High Peaks Church New Sanctuary Project

RE: High Peaks Church (formerly known as North Country Christian Center Church)
97 Will Rogers Drive, Saranac Lake, NY 12983
Sanctuary Addition Construction Project – Visual Assessment

This summary was prepared in response to your emailed comments dated 3/13/23 regarding assessing visual impacts for the above project as it relates to its proximity to NY Route 86 (Lake Flower Ave). More specifically, the proposed project requires expansion of existing deforested land east of NY-86 to construct the planned parking lot and other project related site amenities. As such, the attached schematics/attachments (SK-1 thru SK-11) were prepared to provide additional information for the Boards review and consideration relative to visual impact of the project, including; clarification of required land clearing for the project, elevation and distance data relative to the proximity of proposed land/tree clearing nearest NY-86, an assessment of existing vegetation/trees within the area of forest to remain (on adjoining lands) between the project development area and NY-86, and photographic documentation along NY-86 to assess the perceived visibility of the

PROPOSED CLEARING LIMITS SCHEMATIC

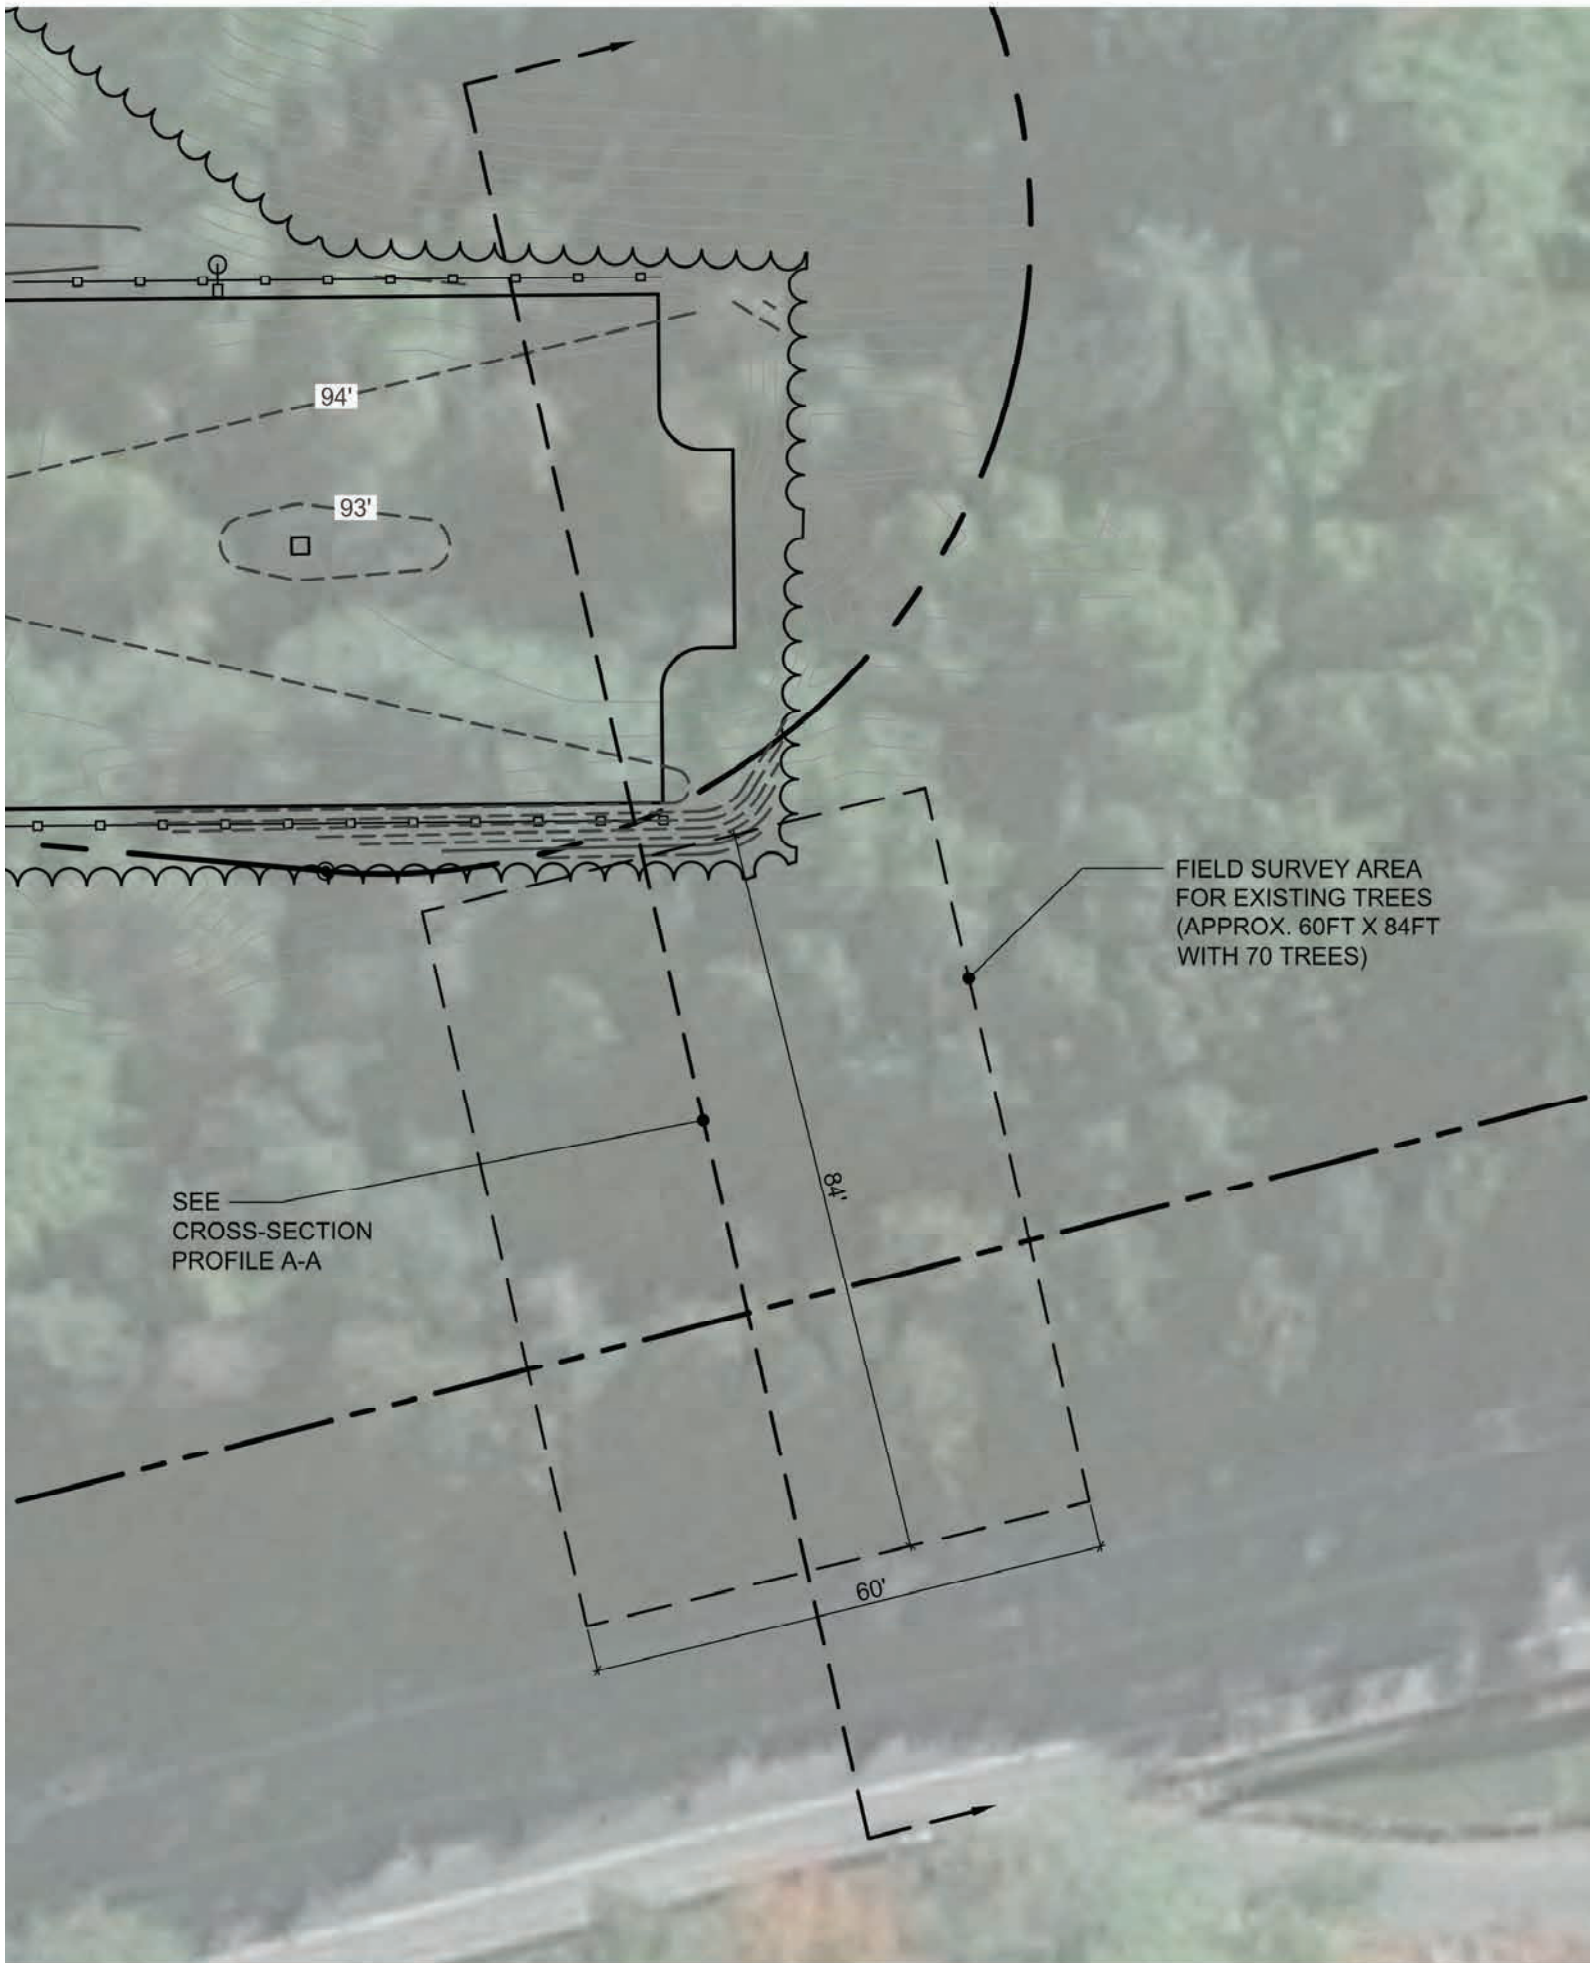
2. The closest point of the planned development area (south-west corner) where tree clearing will occur for the project is approximately 84ft (horizontal distance) from the nearest eastern edge of NY-86. As travelers head north along NY-86 this separation distance increases from its closest point at 84ft, to a distance of 188ft from the edge of road. A dense natural buffer/stand of trees exists within this land area separating the project site from NY-86, approximately 1.5 acres in size with an average forest density of 600 trees per acre (based upon the field survey conducted/shown). This significantly mitigates any potential for negative visual impacts from the planned project. Additionally, the forested buffer area is predominantly conifers, with fewer/mixed deciduous species, which provides year-round visual obstruction and mitigation for any perceived project related visual impact.

PROFILE SECTION A-A

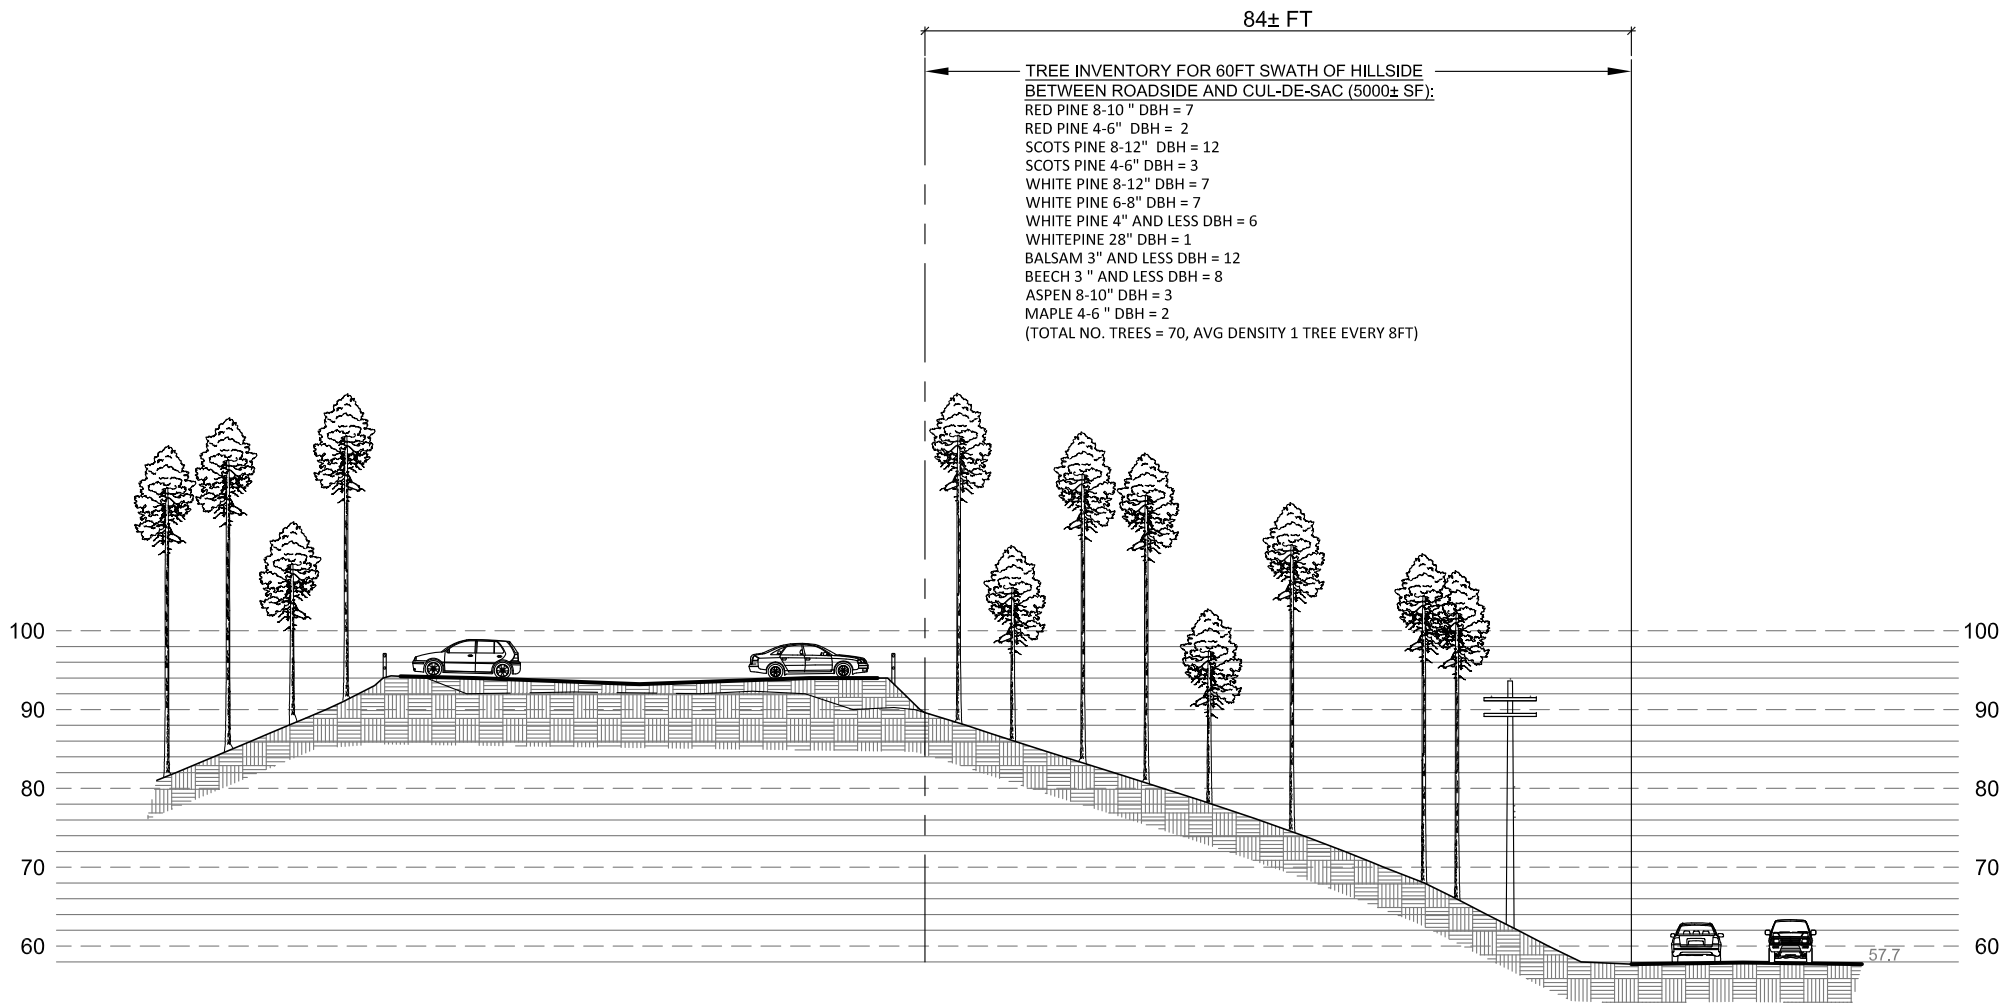
1. The elevation of NY-86 nearest the proposed project is reference elevation 57.7ft. The elevation of proposed tree clearing (at the project parking lot) is 94.0ft. This results in an elevation difference of 36.3ft from NY-86 up to the project site. Travelers along NY-86 would predominantly observe conditions at eye level as they travel along this

SK-5

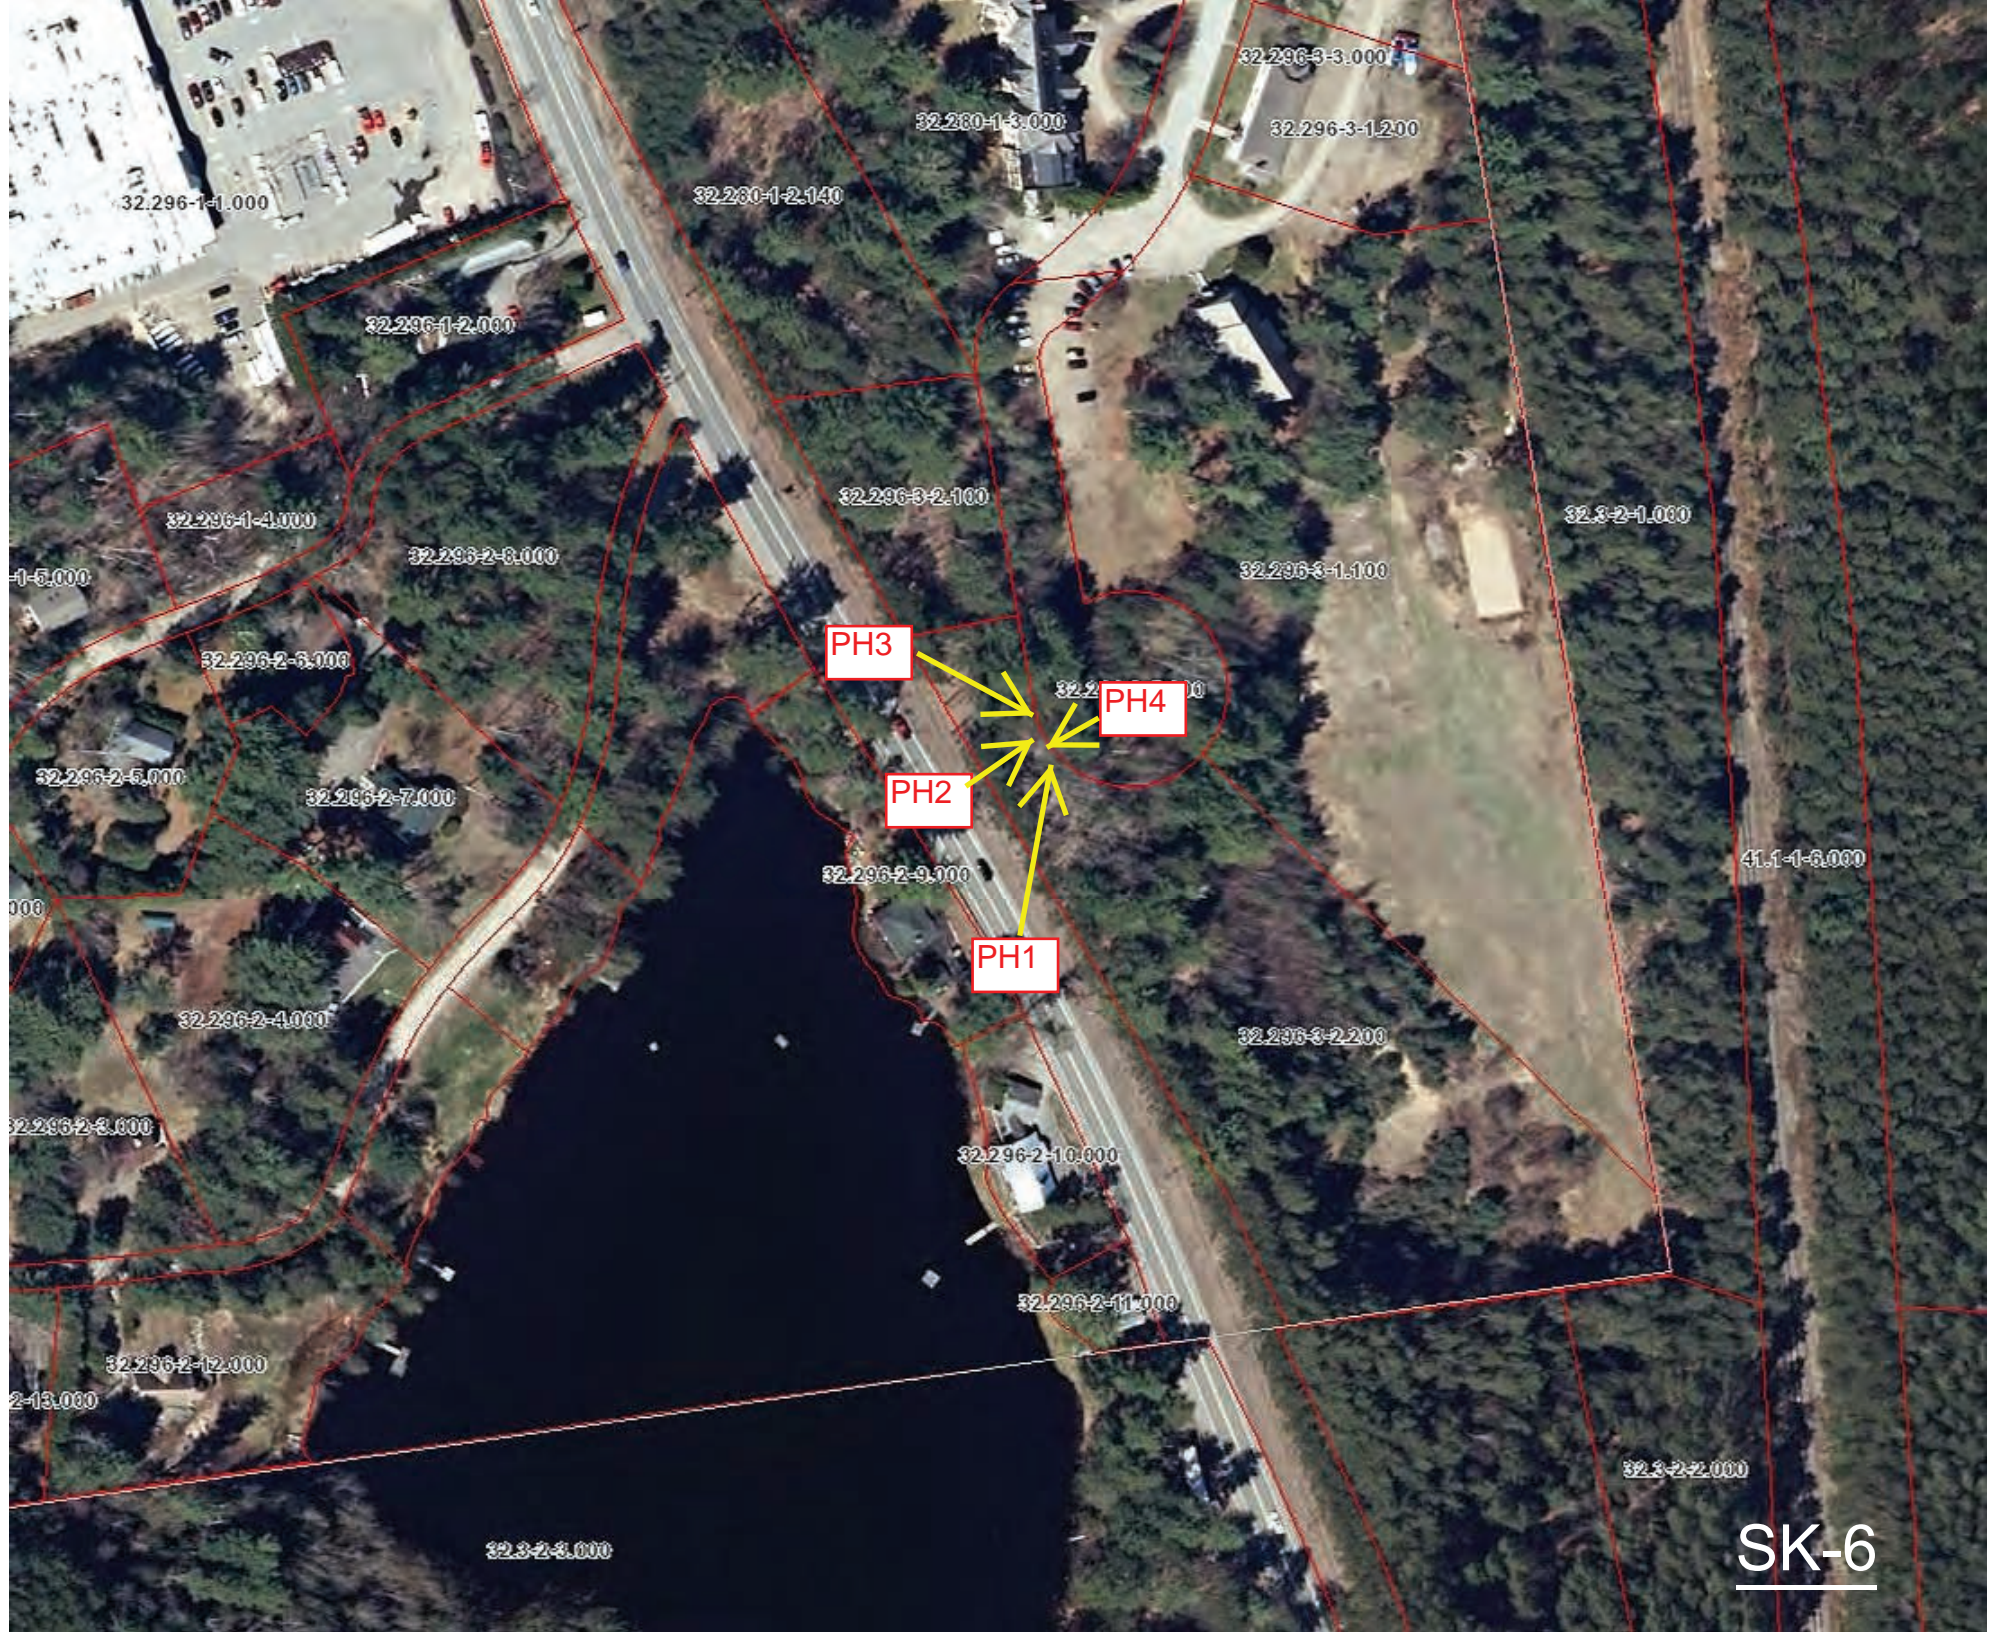
route. The most predominant visual land/aesthetic features east of NY-86 from the roadway are (refer to SK-4 & SK-5);

- utility lines and poles
- the barren steep embankment (covered in woody debris and pine needles)
- a fairly dense stand of conifers and their tree trunks
